No. EL/3.2.66

### **Modification Sheet No. RDSO/WAM4/198.**

1. **Title :** Improvement in the design of armature shaft of TAO-659 Traction Motors.
2. **Application :** TAO-659 TRACTION MOTORS.
- 3.0 **Object :** Since very beginning, TAO-659 Traction Motors are failing on account of the breakage of armature shaft at the set ring groove zone. On investigation in the past, it was noticed that these failures were due to the improper machining of set ring groove which causes development of fatigue stresses at set ring zone.

| RDSO. ELECT. DTE.                             |             | SKEL – 4412                                  |

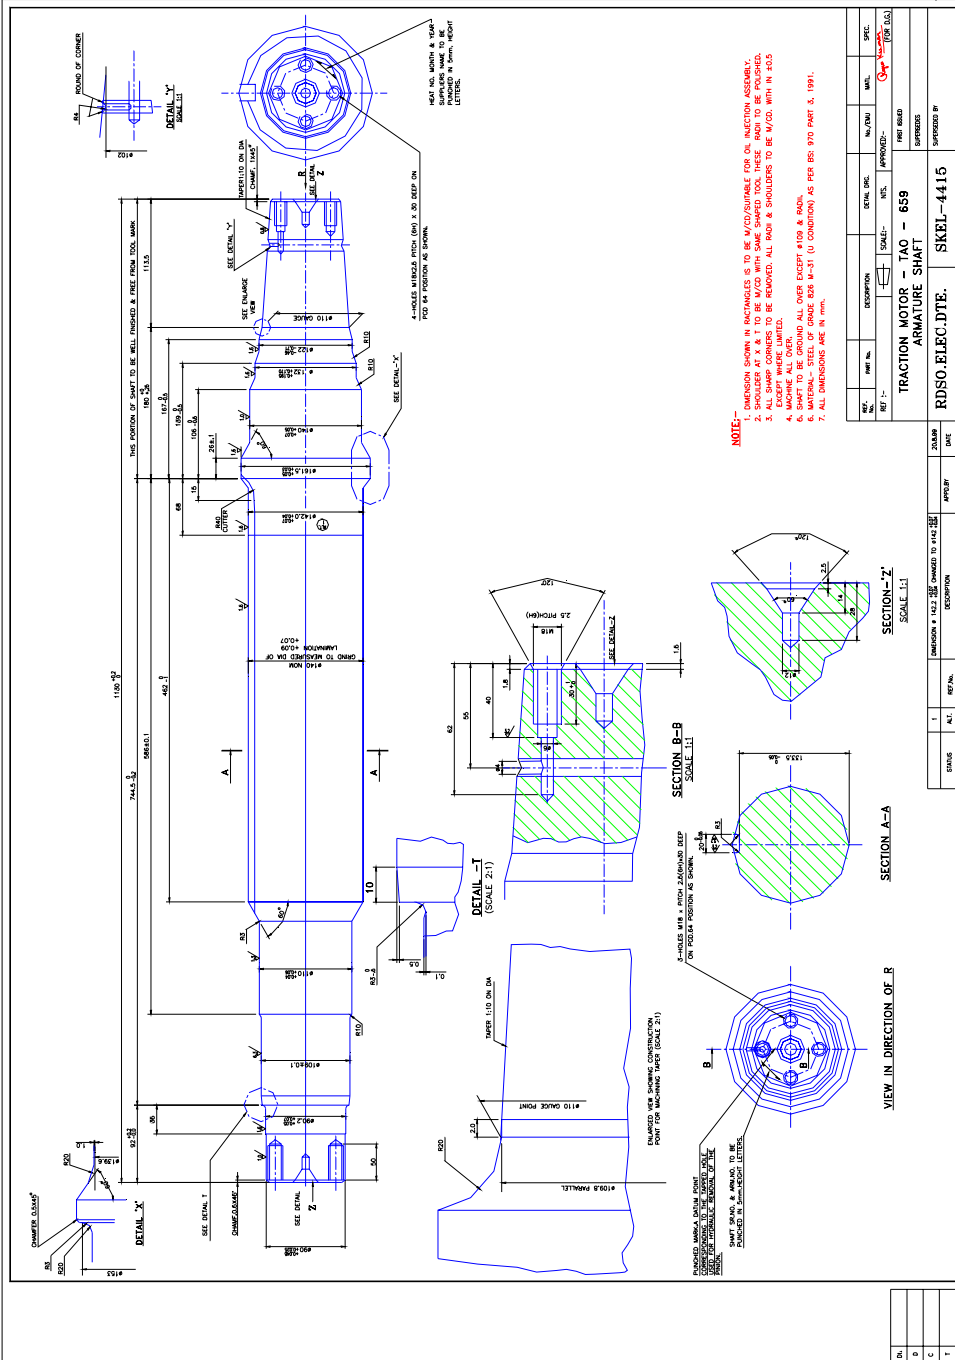
without set ring groove as per RDSO Drawing No. SKEL. 4415 and corresponding modified armature sleeve as per Drg. No. SKEL. 4416. Alternatively, modified additional sleeve to RDSO Drg. No. SKEL. 4412 may be provided on existing armatures during reshafting.

- Remove the wornout/broken armature from the stacked armature core.
- Reinsert the modified armature shaft manufactured as per RDSO Drg. NO. SKEL.4415 in the stacked armature core and mount the armature sleeve and additional sleeve manufactured as per RDSO Drg. No. SKEL. 4412 as per existing procedure.

RDSO Drg. No. SKEL. 4415 for modified armature shaft, SKEL. 4416 for modified armature sleeve and SKEL. 4412 for modified additional sleeve.
